**DEPARTMENT OF TRANSPORTATION
STATE OF GEORGIA**

FILE P.I. No. 422230-, Clay/Randolph Counties
EDS00-0027-00(159)
SR 1/US 27 Widening from Bluffton Bypass
To CR 153/Carnegie Vilulah Road

SUBJECT APPROVED REVISED PROJECT CONCEPT REPORT

REVISED PROJECT CONCEPT REPORT

Typical Section No. 3
 US 27/SR 1

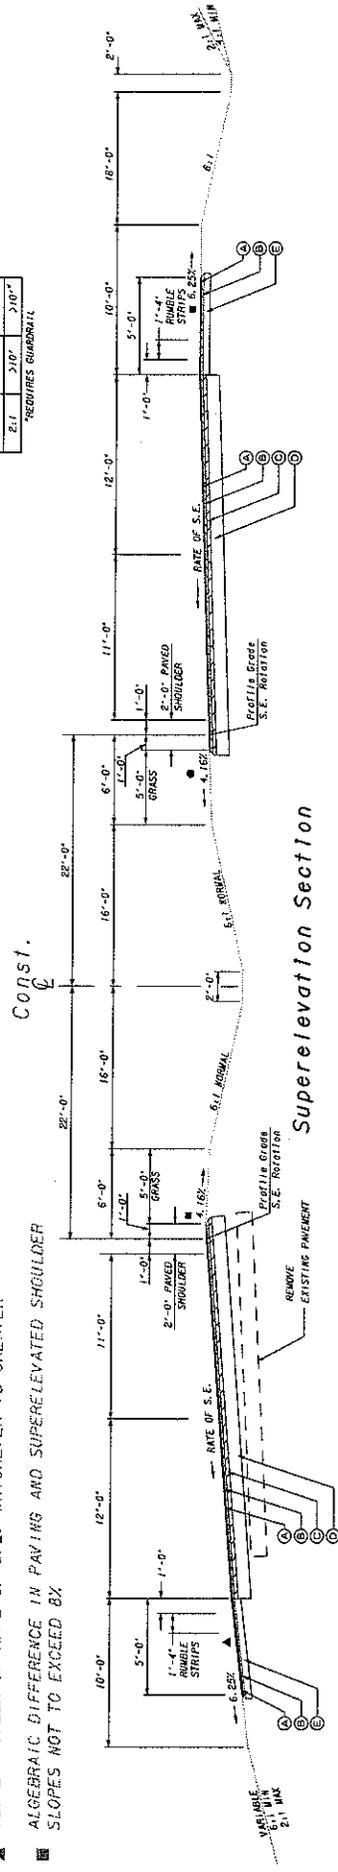
| <p>Approved Features: The proposed alignment is recommended for revision in the vicinity of the Sutton's Corner community. In addition, the proposed mainline widths of the inside travel lanes and outside paved shoulder are recommended for revision.</p> | <p>Proposed Features: Beginning 0.4 miles south of CR 19/ Chulee Road, the proposed roadway would go on new location to the west and roughly parallel to existing US 27. It would intersect SR 37/ Hartford Road 0.2 miles to the west from US 27's existing location. This is necessary to further minimize impacts to the Sutton's Corner historic district. The alignment would then return to the east side of the existing US 27 roadway approximately 0.5 miles north of SR 37/ Hartford Road. The portion of the existing US 27/ SR 1 roadway from CR 19/ Chulee Road to approximately 0.3 miles north of SR 37/ Hartford Road would be retained for local traffic. As a result of the above, the new project length would be 7.9 miles.</p> <p>The width of the US 27/SR 1 mainline inside travel lanes would be reduced from 12 ft to 11 ft. Conversely, the width of the depressed median would increase from 44 ft to 46 ft.</p> |
| <p>Reason for Change: The proposed alignment is recommended for revision in order to further minimize social and agricultural impacts at and to the south of the Sutton's Corner historic district.</p> <p>A value engineering study report, dated September 2008, was performed for the project. Based upon the implementation of the value engineering study report, dated November 26, 2008, the typical section is recommended for revision in order to reduce construction costs by having less pavement.</p> | |
